RESPONSE TO REQUEST FOR ADDITIONAL INFORMATION

APR1400 Design Certification

RAI No.: 233-8244
SRP Section: 05.02.02 - Overpressure Protection
Application Section: 5.2.2, 5.4.10 and 6.4.14
Date of RAI Issue: 10/02/2015

Question No. 05.02.02-2

Figure 2.4.1-2 Reactor Coolant System (Pressurizer)

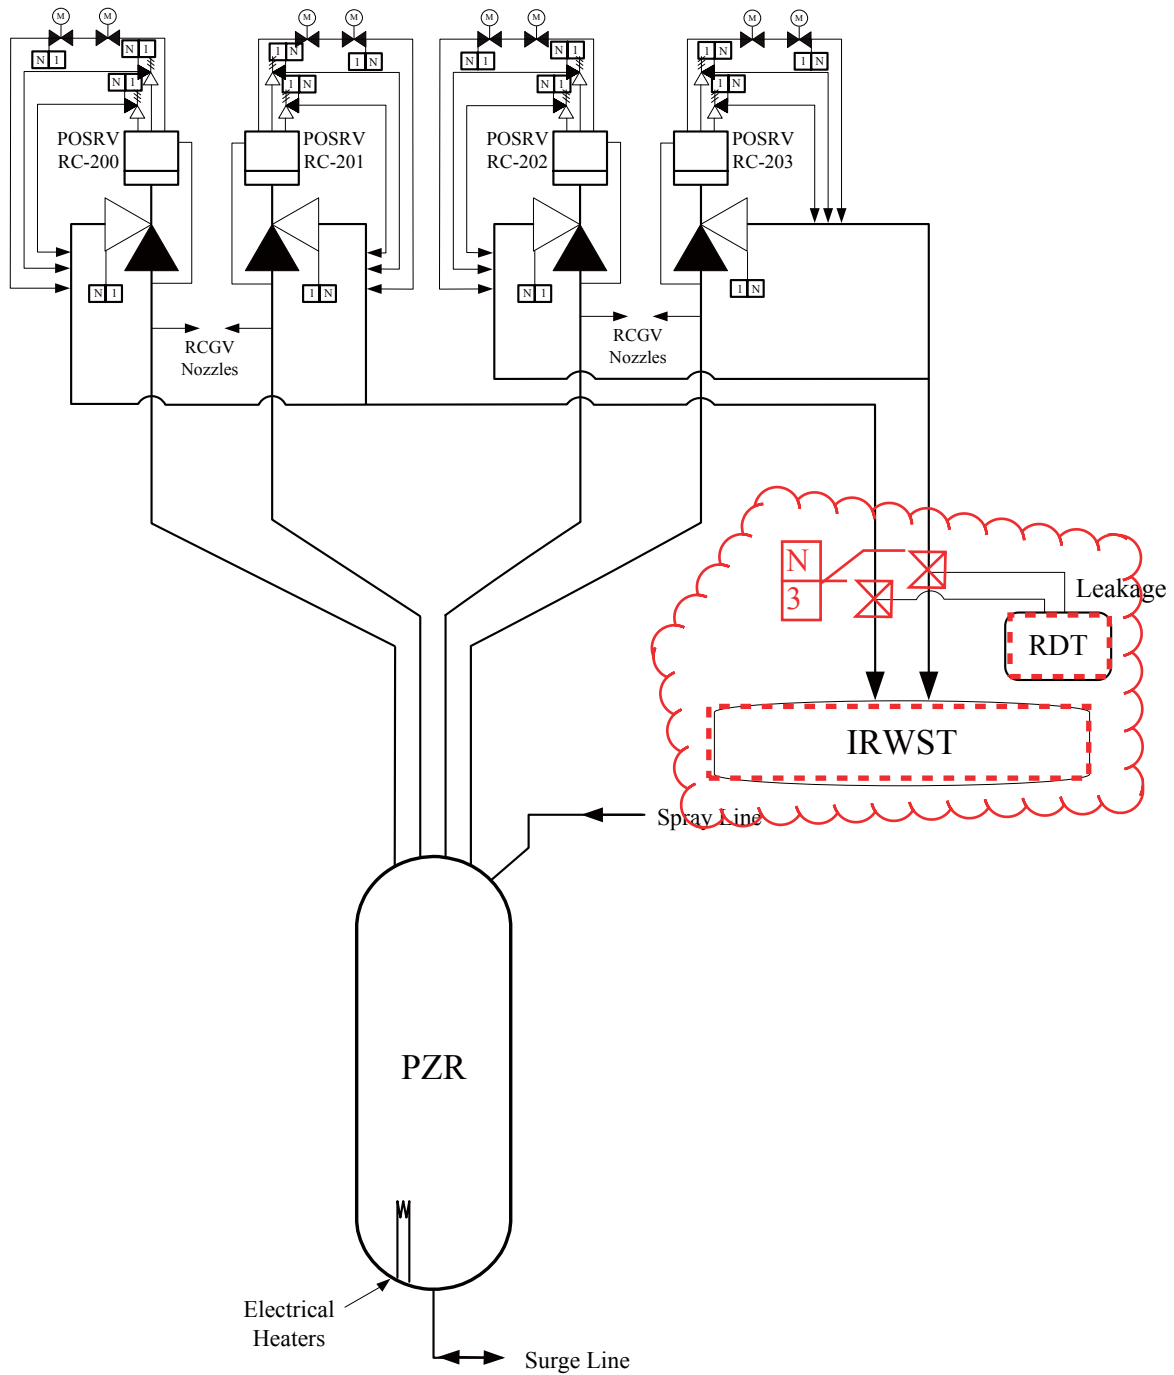
- b. DCD Section 5.2.2.3, "Flow Diagrams," provides the reference to flow diagrams for the overpressure components and states, "The flow diagram showing the in-containment refueling water storage tank (IRWST) is given in Figure 6.8-3." DCD Tier 1, Figure 2.4.2-1 shows the discharge of the POSRV into the IRWST. Figure 6.8-3, "Incontainment Water Storage System Flow Diagram," shows the piping connections for the SCS relief valve discharge, but the staff is unable to locate the POSRV discharge connections to the IWRST. The applicant is requested to verify the location of

the POSRV discharge connection to IRWST in Figure 6.8-3. In addition, an inconsistency may exist between Tier 1 and 2 regarding this piping configuration. The applicant should verify the proper configuration and update DCD for consistency

DCD Tier 1 Table 2.4.1-1, Table 2.4.1-2, and Figure 2.4.2-1 will be revised to clarify the classification of the POSRV discharge piping and to be consistent between the DCDs.

- b. The location of the POSRV discharge connection to the IRWST is shown on Figure 2.4.1-2 in Tier 1 and Figure 5.1.2-3 in Tier 2, but not Figure 6.8-3, each of which is the schematic and flow diagram for Pressurizer and POSRV including the portion of the POSRV discharge, respectively. Therefore consistency exists between Tier 1 and Tier 2. On the other hand, Figure 6.8-3 shows the flow diagram of the in-containment water storage system (IW) and the IW system does not include the portion of the POSRV discharge.

Figure 5.1.2-3 in Tier 2 was revised with the response to RAI 25-7844 Question 06.02.02-3 to indicate the spargers and associated piping as the POSRV discharge.
